# Access Compliance Report

## Public Rights-of-Way

Intersection ID: 31201	Main Street: WRAYHILL_DR	Cross Street: OLDCORN_LN	Location: SW
ADA ID: 6C910264F3E3	Ramp Type: Perp	Initial Pass/Fail: Fail	Overall Compliance: No
		Severity Score: 8.75

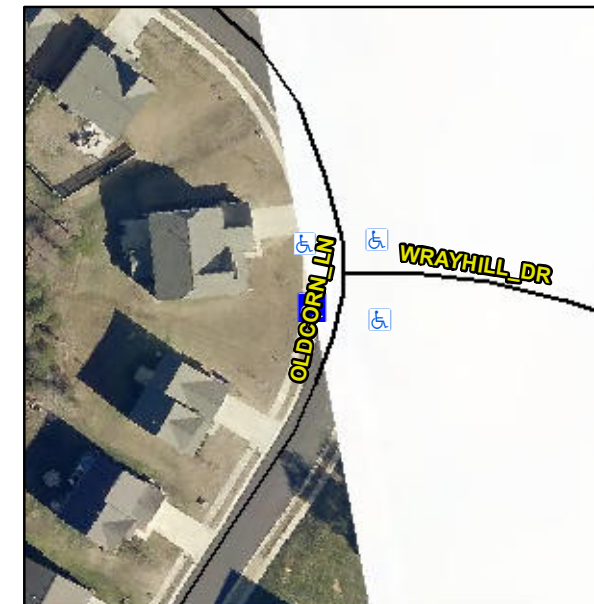
**Not Found, R304.5.1**

Compliance	Description	Data	Compliance	Description	Data
N/A	Ramp Length (in)	48.0	Yes	Ramp Slope (%)	7.9
No	Ramp Width (in)	47.0	Yes	Ramp XSlope (%)	1.5
N/A	Flare Type LT	N/A	N/A	Flare Type RT	N/A
N/A	Flare Slope LT (%)	N/A	N/A	Flare Slope RT (%)	N/A
N/A	Flare Traversable LT?	N/A	N/A	Flare Traversable RT?	N/A
N/A	Landing Length (in)	N/A	N/A	DWS Provided?	N/A
N/A	Landing Width (in)	N/A	N/A	DWS Contrast?	N/A
N/A	Landing Slope (%)	N/A	N/A	DWS Length (in)	N/A
N/A	Landing X Slope (%)	N/A	N/A	DWS Full Width?	N/A
N/A	Landing Curb? (Y/N)	N/A	N/A	DWS Offset (in)	N/A
N/A	Shared Landing?	N/A			
N/A	Gutter Ponding?	N/A	N/A	Gutter Slope (%)	N/A
N/A	Gutter Lip Ht (in)	N/A	N/A	Gutter X Slope (%)	N/A
N/A	Painted X Walk1?	No	N/A	Painted X Walk2?	N/A
	X Walk 1 Direction	To E		X Walk 2 Direction	N/A
N/A	X Walk 1 Width (in)	N/A	N/A	X Walk 2 Width (in)	N/A
	X Walk 1 Slope (%)	4.9		X Walk 2 Slope (%)	N/A
	X Walk 1 X Slope (%)	1.2		X Walk 2 X Slope (%)	N/A

**Remove & Replace Entire Ramp.**
